# Bulletin Number - BP4C KVC - 02

<b>Project</b>	Steamboat Base Village Redevelopment	<b>Date</b>	12/13/2021
<b>Project Location</b>	Steamboat, Colorado	<b>Architect's Project Number</b>	03.7835.000
<b>Owner/Client</b>	Alterra Mountain Company / East West Partners	<b>File</b>	6BL <b>This is page</b> 1 of 2
<b>To</b>	Saunders Construction Inc.	<b>Attention</b>	Bryan Sculthorpe
<b>Address</b>	86 Inverness Place North		
<b>City</b>	Englewood	<b>State</b>	CO <b>Zip Code</b> 80112
<b>Delivered via:</b>	<input type="checkbox"/> <b>Messenger</b> <input type="checkbox"/> <b>Hand carried</b> <input type="checkbox"/> <b>Facsimile</b> <input type="checkbox"/> <b>Express</b> <input type="checkbox"/> <b>Pick-up</b> <input type="checkbox"/> <b>E-mail Address</b> <input type="checkbox"/> <b>Mail</b> <input type="checkbox"/> <b>UPS</b> <input checked="" type="checkbox"/> <b>Website Address</b> BIM360

### Description of Changes

- Updated MEP and arch roof plan
- Updated steel reinforcing for roof (sketch)

**1C-M8.001**

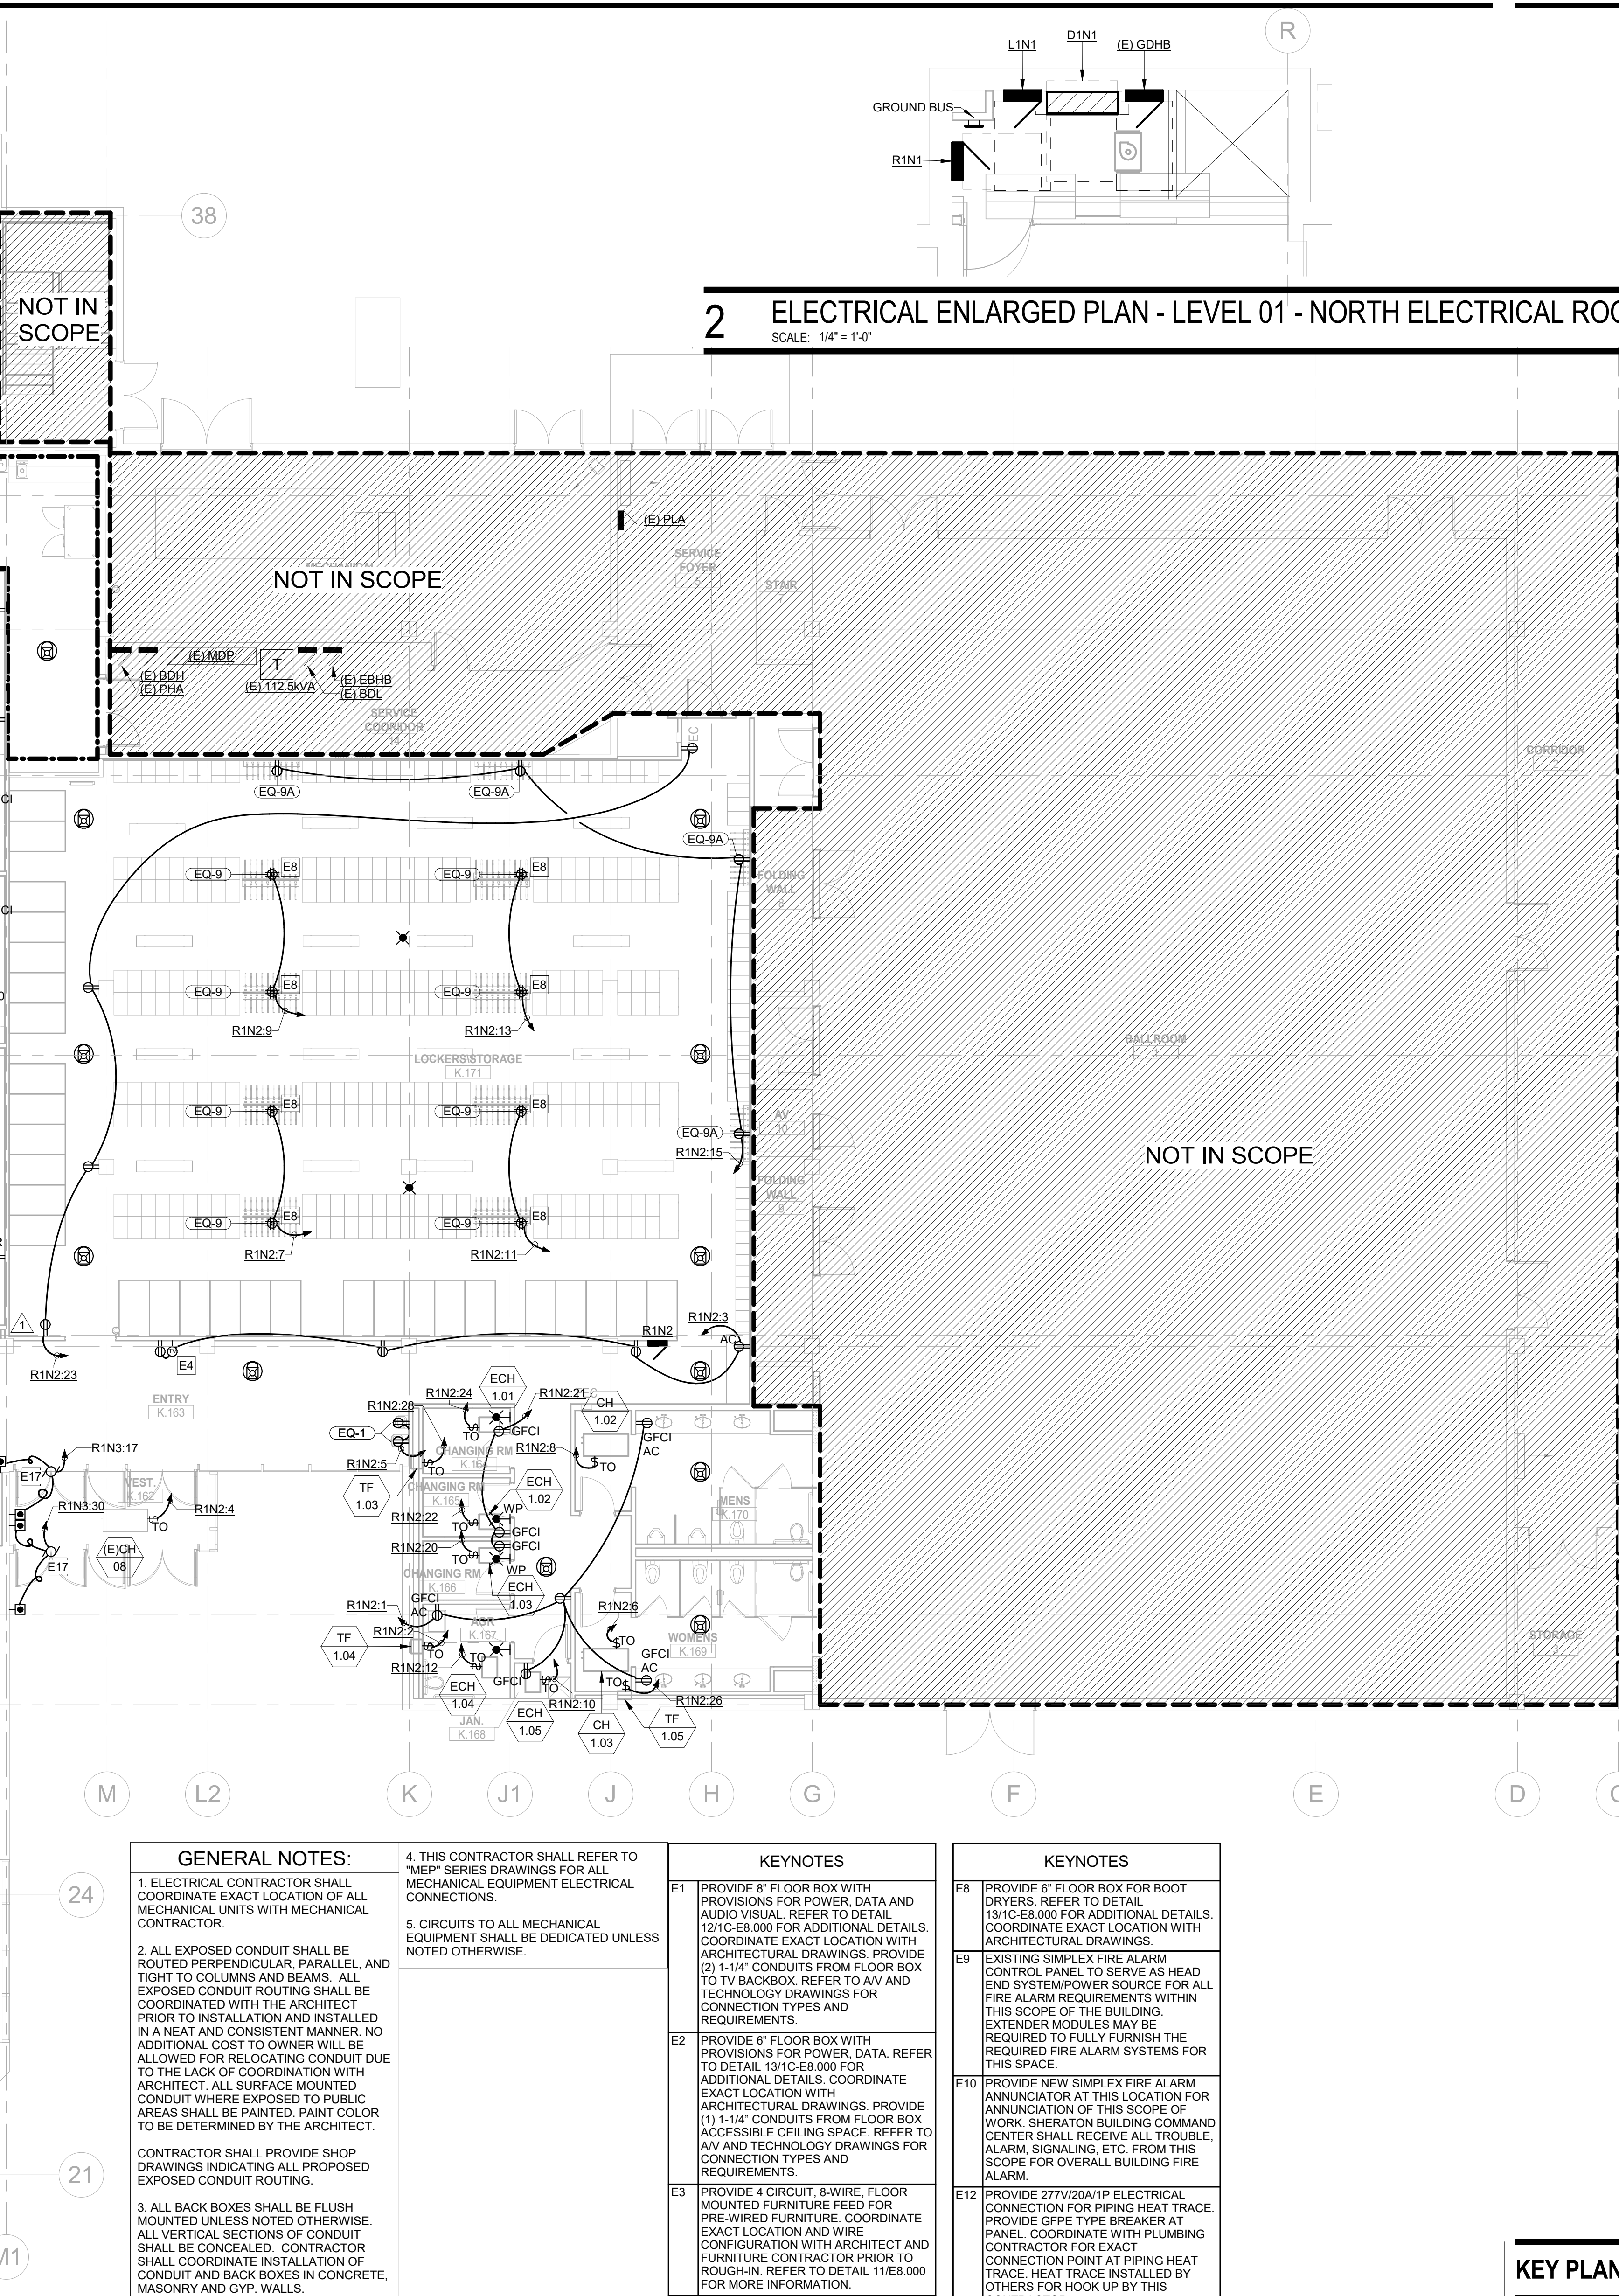
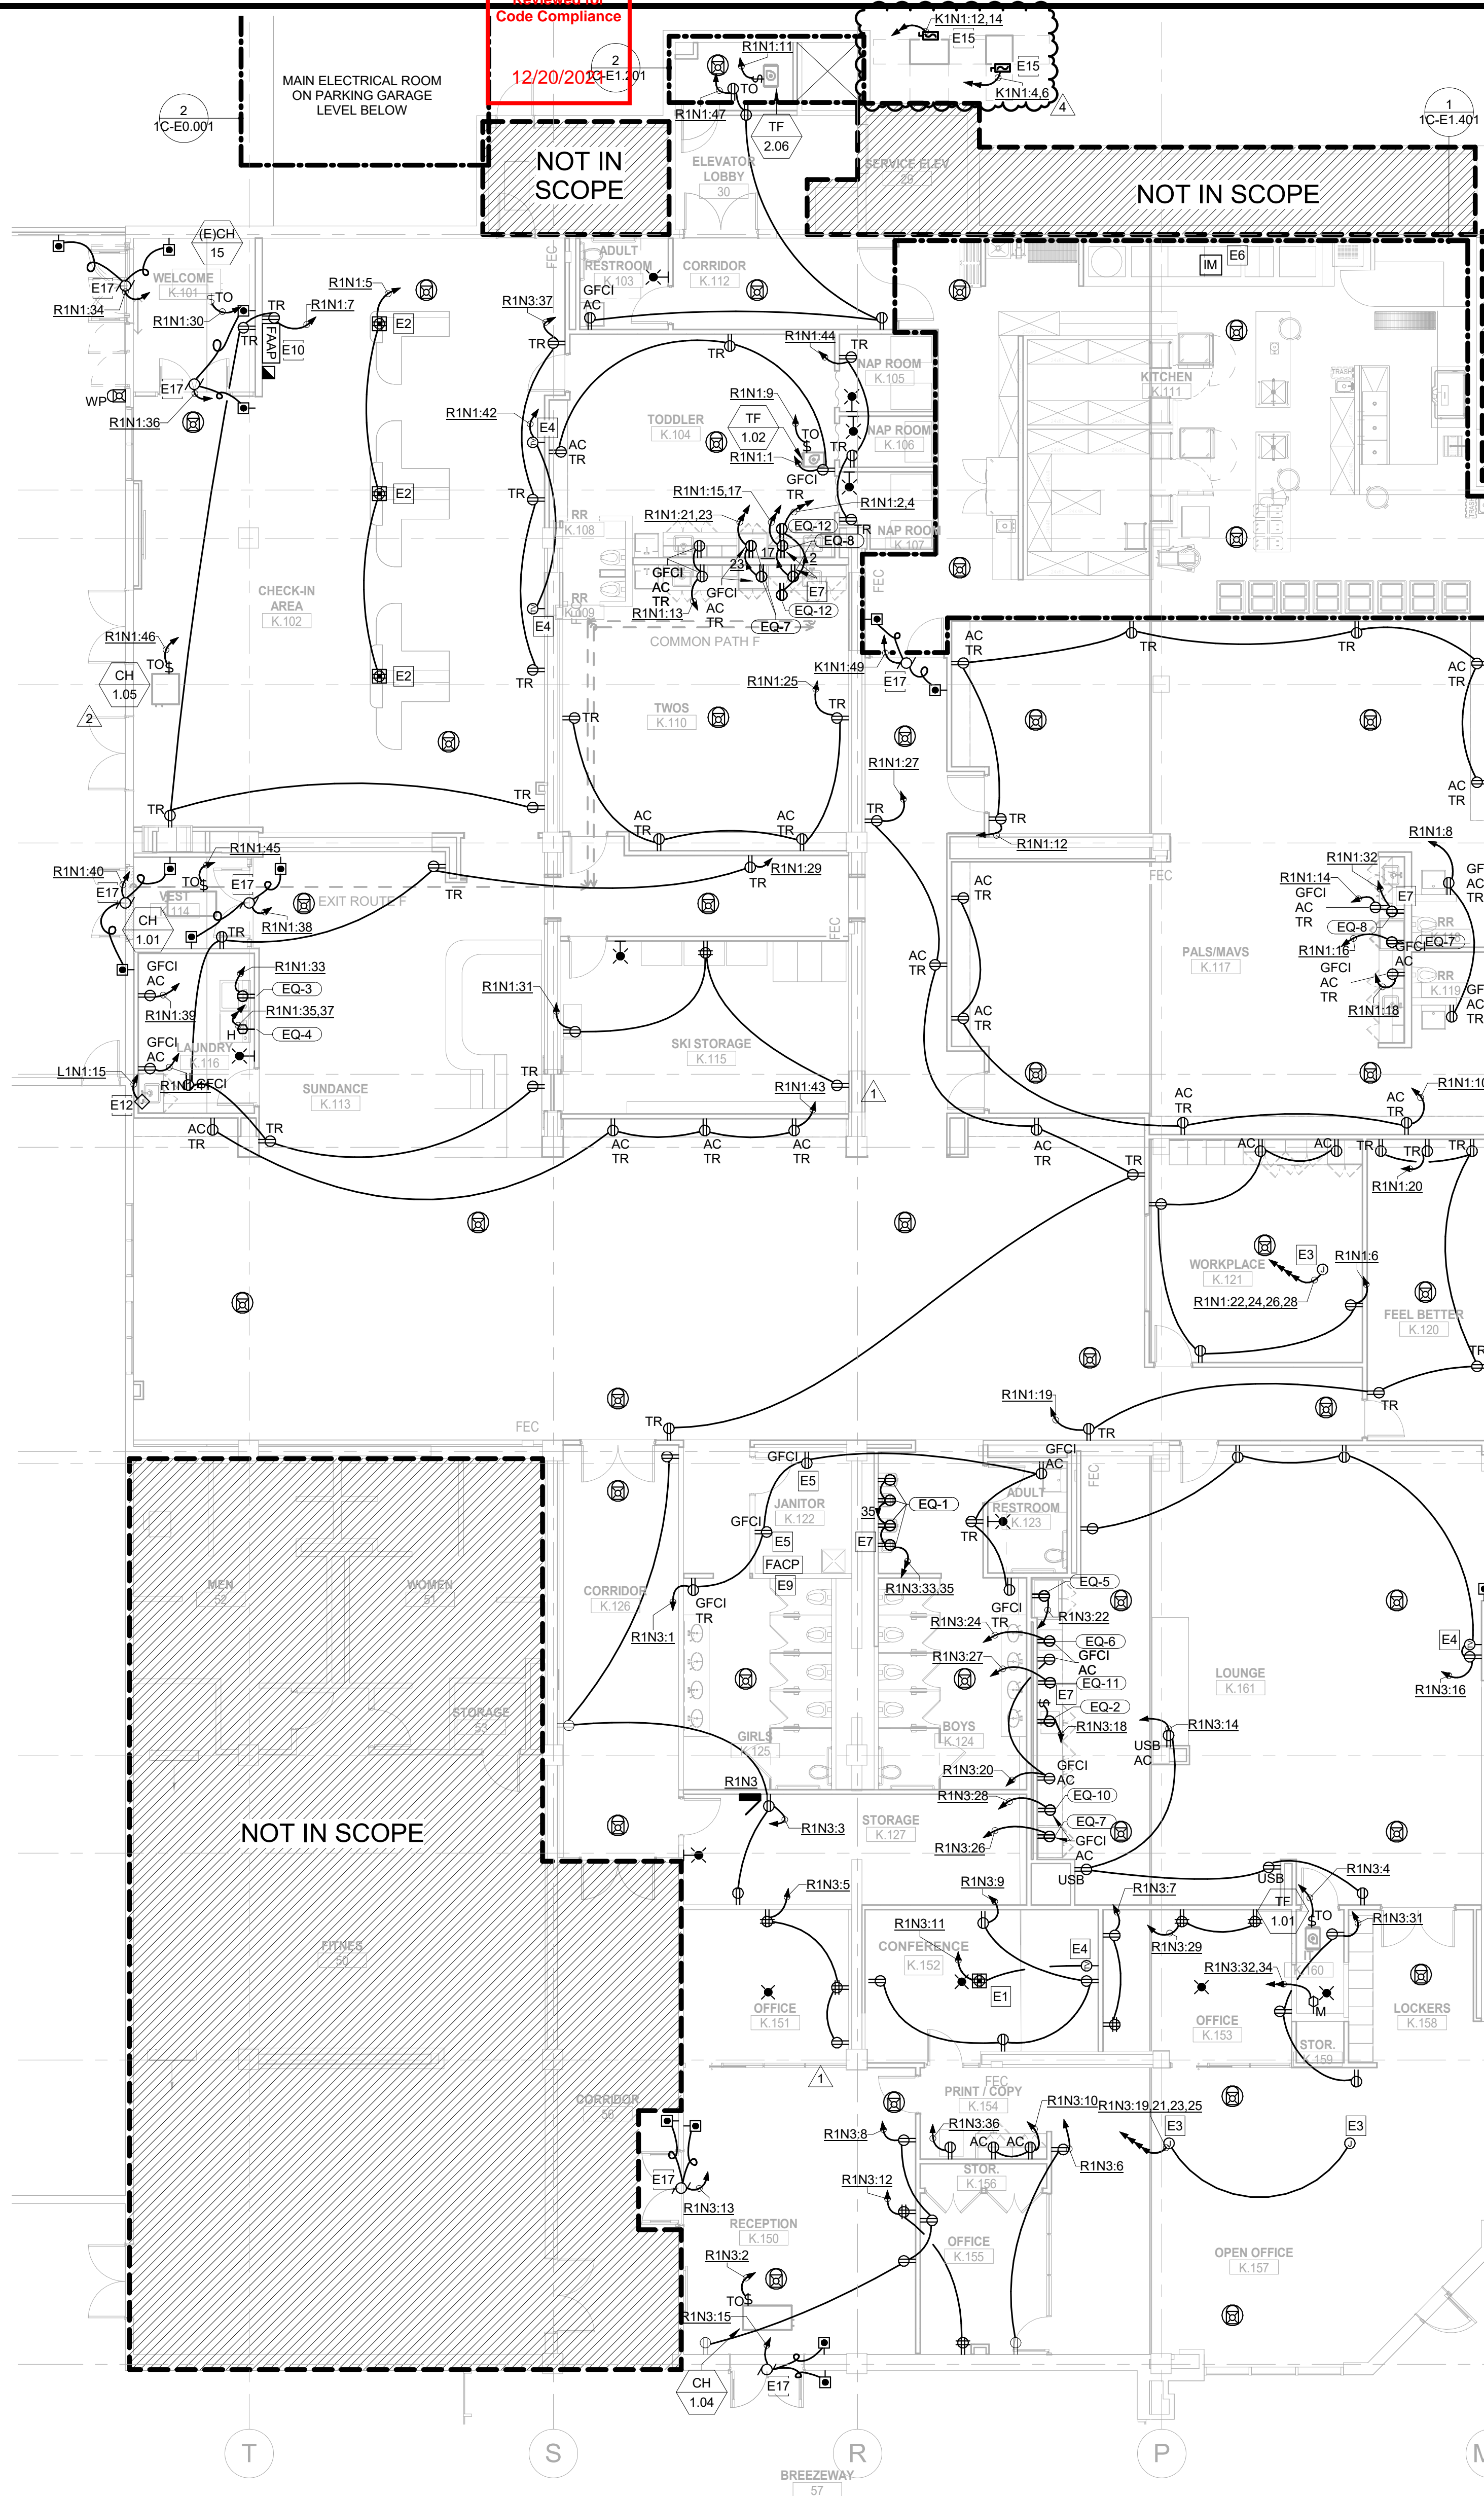
- 1C-DM1-101
  - Revised demolition scope
- 1C-M1.201
  - Relocated walk-in cooler condensing unit to grade level outside building.
  - Revised sheet metal layout in kitchen to accommodate existing hydronic piping mains.
- 1C-M1.202
  - Relocated grease exhaust fan and makeup air unit on roof. Relocated food service condensing units to grade level outside building.
- 1C-M8.001
  - Added detail for sheet metal around existing hydronic piping mains.
